**TRANSMITTAL OF: (1) RESPONSES TO THE U.S. ENVIRONMENTAL PROTECTION AGENCY AND OHIO ENVIRONMENTAL PROTECTION AGENCY COMMENTS ON THE SITEWIDE COMPREHENSIVE ENVIRONMENTAL RESPONSE, COMPENSATION, AND LIABILITY ACT QUALITY ASSURANCE PROJECT PLAN REVISION 1, (2) MODEL QUALITY ASSURANCE PROJECT PLAN CROSS REFERENCE TABLE**

**RESPONSES TO U.S. EPA AND OHIO  
EPA COMMENTS ON THE SITEWIDE  
CERCLA QUALITY ASSURANCE  
PROJECT PLAN (SCQ) REVISION 01**

**FERNALD ENVIRONMENTAL MANAGEMENT PROJECT  
FERNALD, OHIO**

**FEBRUARY 1998**

Figure F-1. Relationship of FEMF Environmental Databases.

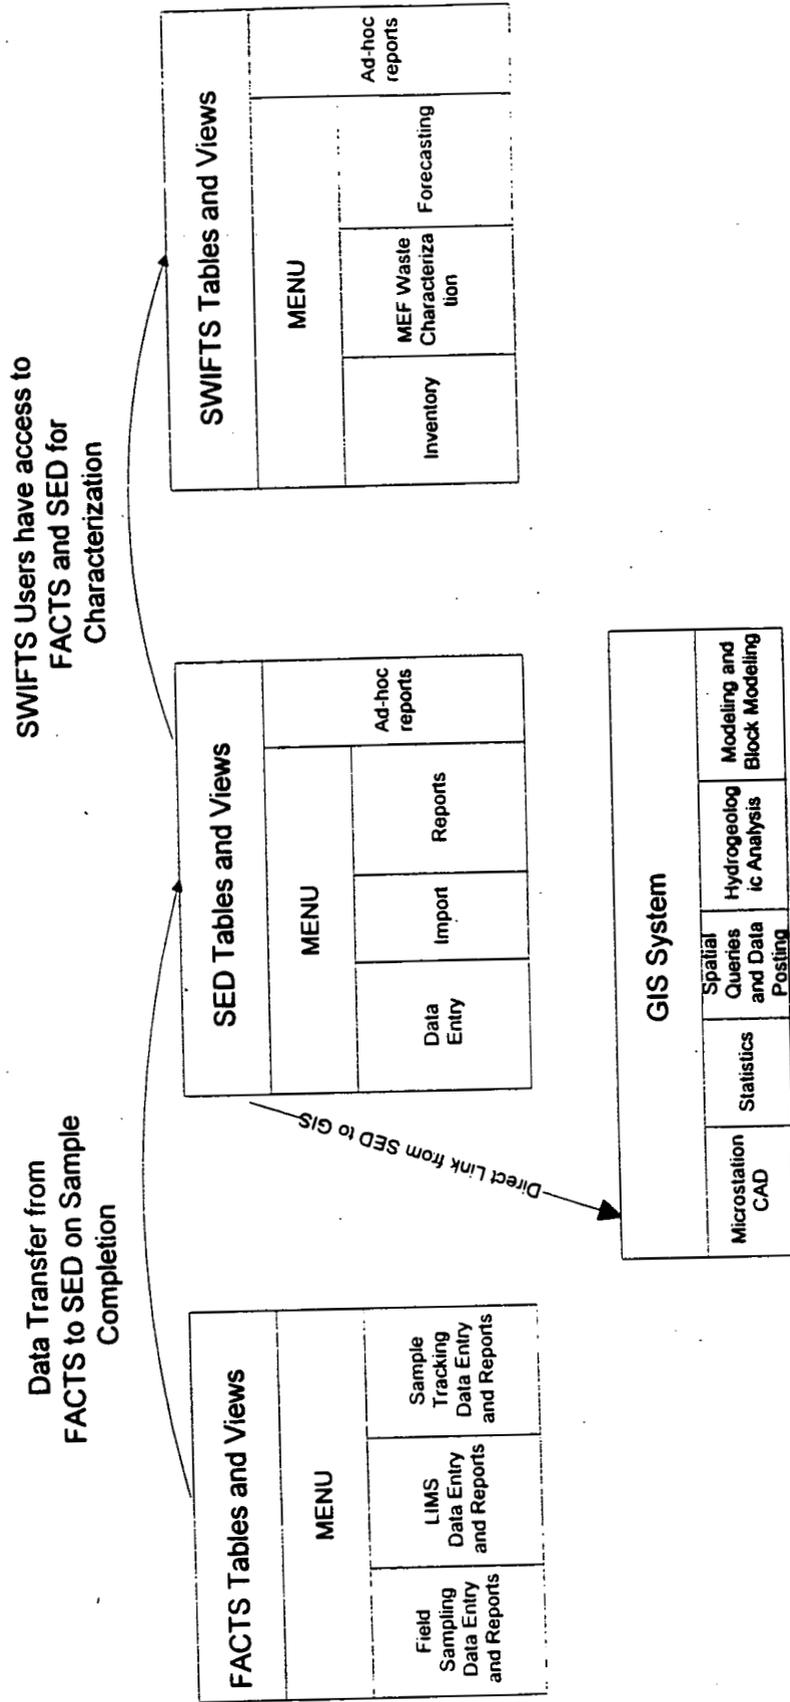
144. Commenting Organization: OEPA Commentor: OFFO  
 Section #: F.4.1 Page #: F-4 Line #: 36  
 Original Specific Comment #: 28  
 Comment: An explanation of the FACTS system and included subsystems may be easier to understand if a graphical explanation of the subsystems and how they are linked is included. This comment is also applicable to the SED section in F.4.3.  
 Response: We agree with the comment.  
 Action: Figure F-1, "Relationship of FEMP Environmental Databases" has been added to Appendix A, new page A-4. A copy of the new figure is attached at the end of these comments.

Response: We agree that the text of the SCQ contained imprecise descriptions of the SED database. We have revised the text to remove confusing statements. The relationship of the databases is addressed in our response to DOE Comment #93.
